6. Galetti Subdivision; KPB File 2024-026 Edge Survey & Design, LLC / Galetti Location: A Private Road Sterling Area

### ITEM #6 - PRELIMINARY PLAT GALETTI SUBDIVISION

KPB File No.	2024-026
Plat Committee Meeting:	March 25, 2024
Applicant / Owner:	Walter E & Gesena M Galetti of Sterling
Surveyor:	Jason Young and Mark Aimonetti / Edge Survey and Design, LLC
General Location:	Sterling Moose River

#### GALETTI SUBDIVISION

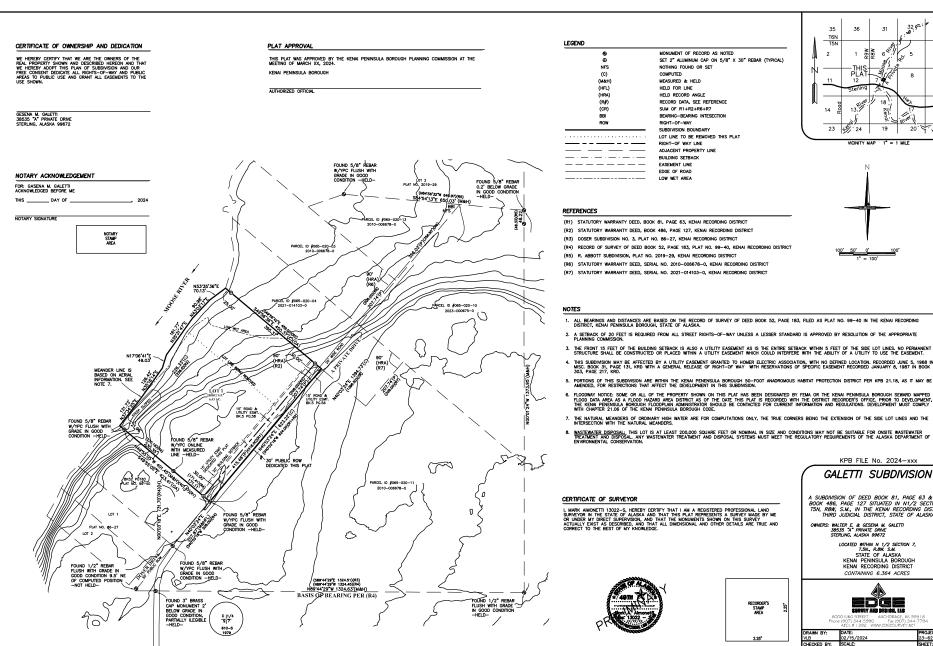
There are no section line easements or patent easement. The plat is subject to a 15 foot road easement as mention in several transactions and in the certificate to plat, but the source document of this easement is not listed. **Staff recommends**; the surveyor add a plat note mentioning this 15 foot road easement and the documents in the certificate to plat.

There is a steep area in the southwest corner of the plat. the steep area is indicated on the supplemental drawing. the surveyor should add the steep area to drawing and contours can be removed from the final.

There are wetlands and a FEMA flood hazard area designated on the area of the plat. The proper flood hazard notice is given at plat note #6. The title "Floodway Notice" should be changed to "Flood Hazard Notice" Areas in the flood zone should be idented on the final.

- Add to KPB file no 2024-026
- The road label to the east. Change label to A Private Rd
- Any area of the subdivision within the floodplain, floodway or Seward Mapped Flood Data Area (SMFDA) is to be shown and labeled on the plat.

Show the line for the dedication as a solid line.

Give bearing and distance along right of way line

The parcel directly north, put a connector arrow / line to show the parcel is also across the road.

For the area of Lot 1, remove the area of the right of way, include only the area of Lot 1

- Add a plat note concerning the 15 foot road and utility easements listed in the CTP and that the source document is not given.
- place a note on the final plat indicating any person developing the property is responsible for obtaining all required local, state, and federal permits, including a U.S. Army Corps of Engineers wetland determination

- Add to the Plat Approval the date of March 25, 2024
- Walter Galetti needs to be added to the Certificate of Ownership and Dedication and the Notary Acknowledgement.
